TfNSW Reference: SYD22/00674/01

RE: TfNSW's ADVISE TO DETERMINE GATEWAY CONDITIONS FOR TRAFFIC ASSESSMENT OF 'BANKSTOWN CENTRAL SHOPPING CENTRE ("Vicinity")

**RE: PLANNING PROPOSAL FOR 'BANKSTOWN CENTRAL SHOPPING CENTRE
("Vicinity")' – BANKSTOWN LOCAL ENVIRONMENTAL PLAN (BLEP) 2015**

**Reference: PLANNING PROPOSAL FOR 'BANKSTOWN CENTRAL SHOPPING CENTRE' –
BANKSTOWN LOCAL ENVIRONMENTAL PLAN (BLEP) 2015 – RESPONSE TO
TFNSW LETTER DATED 18 MAY 2022**

Figure 2.2: Daily Traffic Profile at Macauley Street

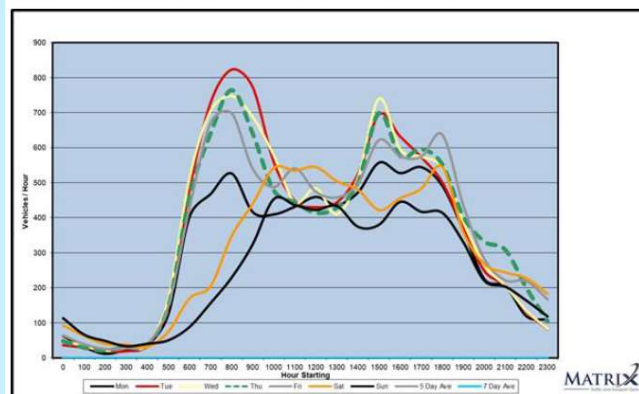
The daily profile at Macauley Street shows that the PM peak at 3pm during the weekday does not align with the PM peak hour identified through all the sites (total) 4-5pm. This implies that the traffic movement has different trip pattern dependent on the origination / destination within the study area.

Figure 1: Proposed Jacobs Street Extension and Bus Interchange – Concept Design

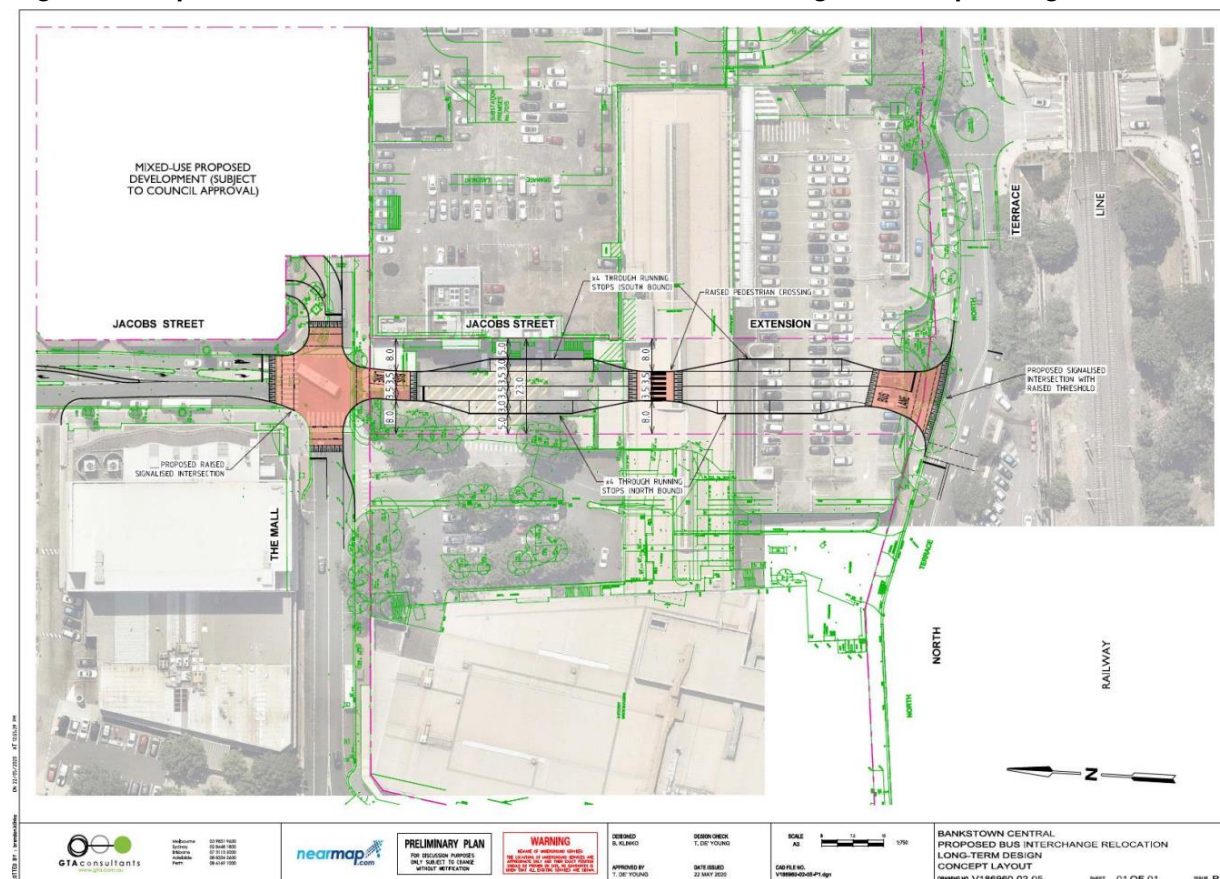
Assess the impacts and opportunities arising from the master plan proposal on travel demands and operation of the rail and bus networks and future Metro.

The July 2020 TIA contains extensive discussion on the impacts and opportunities with respect to the bus network, including (most notably) the construction of the Jacobs Street extension to provide an on-street bus interchange.

Specifically, the TIA includes a concept layout plan for the on-street bus interchange with the provision of 8 on-street bus bays. This concept layout is reproduced below in Figure 1 for reference. It is noted that the provision of 8 bus stops is consistent with the arrangements recently approved by Council and TfNSW for the relocation of the existing bus interchange off the Bankstown Central site. The relocation will see two bus stops provided on Bankstown Central land (together with 10 layover bays), two bus stops located on Jacobs Street north of The Mall, and four bus stops located on The Mall west of Jacobs Street. This arrangement is anticipated up to the delivery of the long-term solution.

Figure 1: Journey to Work Mode Share (ABS Census Data, 2016)

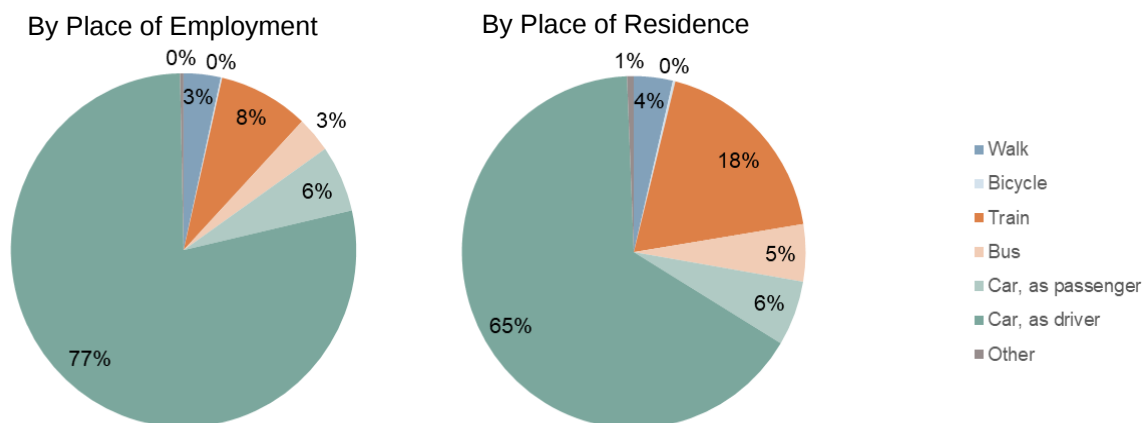
The current capacity of bus and rail services serving Bankstown area should also be analysed to understand if the current public transport have the capacity to accommodate the proposed future public transport usage as indicated in the report. This may require specific measures to improve such public transport usage proposed for the development as well as preparation of a Travel Demand Management Plan and Green Travel Plan.

ABS 2016 mode split data for Bankstown as both an origin and destination for work-based trips is summarised in Figure 1.

The above datasets confirm a heavy reliance on the use of car for travel to/from Bankstown at present and therefore there is no disagreement that the mode share targets set out in the Bankstown Central Planning Proposal TIA will require a significant shift to more sustainable transport modes. However, we consider this significant mode share is appropriate, noting:
